HISTORIC AND DESIGN REVIEW COMMISSION

HDRC CASE NO: 2020-181

ADDRESS: 212 CLAUDIA ST **LEGAL DESCRIPTION:** NCB 2877 BLK 2 LOT 7

TYPE OF WORK: Front yard fencing APPLICATION RECEIVED: April 07, 2020

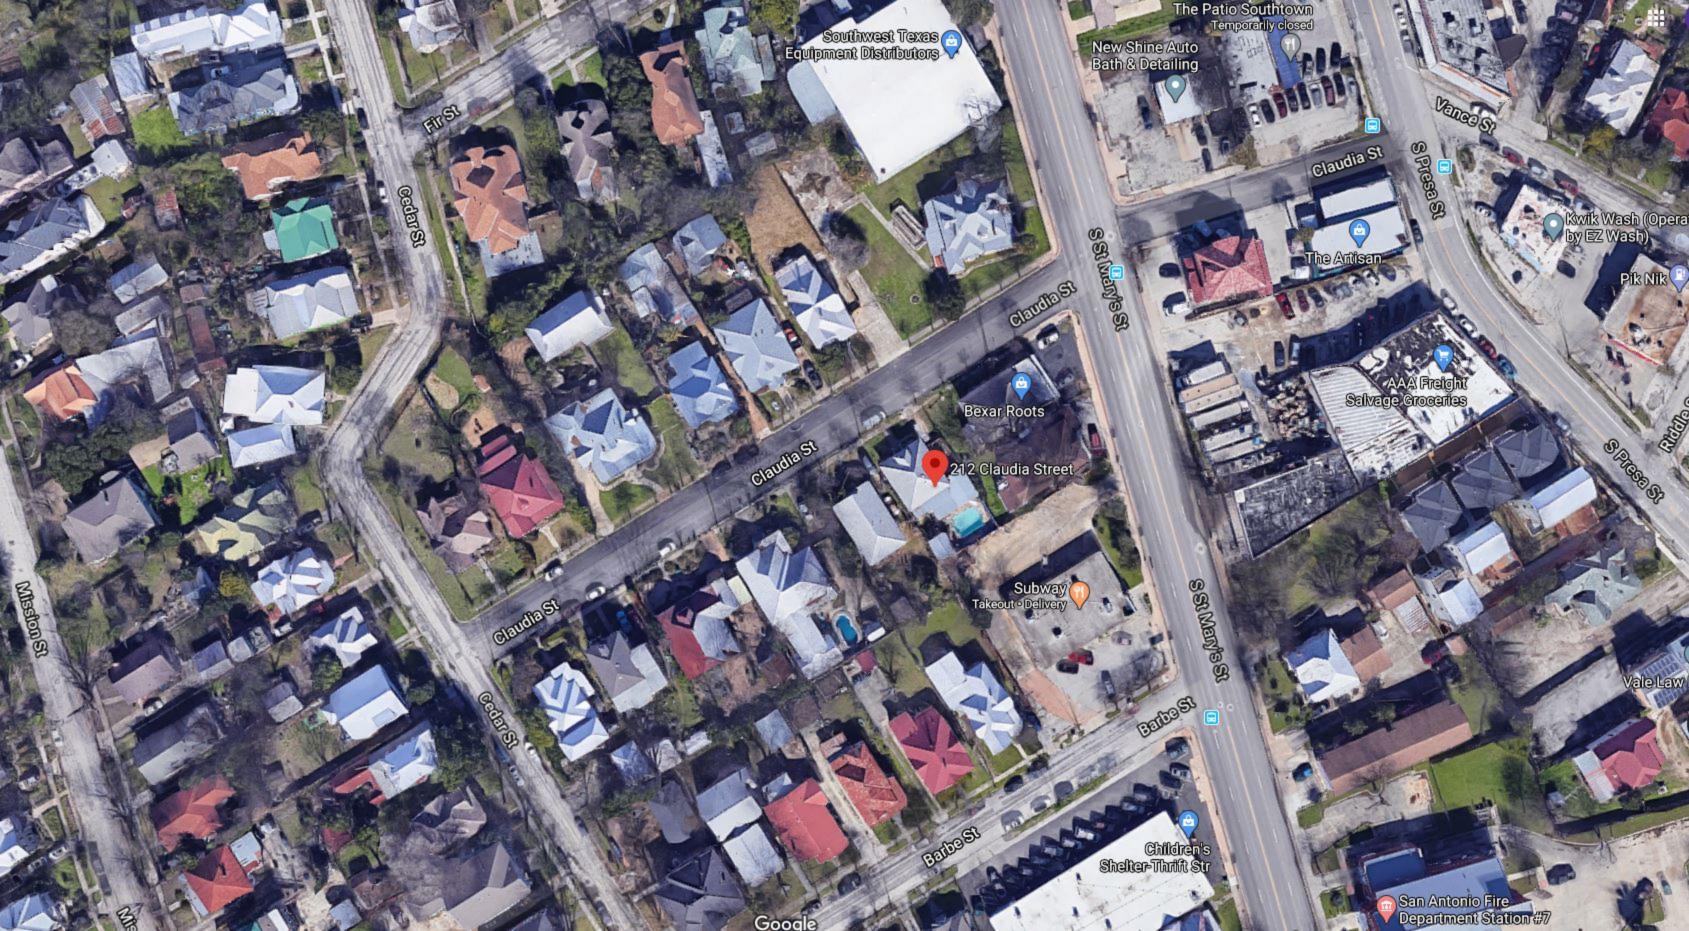
- c. FENCE DESIGN The applicant has proposed to install a wood fence with Gothic style pickets, painted white, and featuring pedestrian gates at the front walkway and side driveway. Per the Guidelines for Site Elements 2.B.i, new fences and walls should appear similar to those used historically within the district in terms of their scale, transparency, and character; the design of fences should respond to the design and materials of the house or main

- structure. Staff finds that the fence design is appropriate to the style and location of the historic structure.
- d. FENCE HEIGHT The applicant has proposed to install a fence with 35" pickets and 42" posts in the yard. Per the Guidelines for Site Elements 2.B.iii, applicants should limit the height of new fences and walls within the front yard to a maximum of four feet; the appropriateness of a front yard fence is dependent on conditions within a specific historic district. Staff finds the proposed height is consistent with the Guidelines.

Staff recommends approved based on findings b through d.
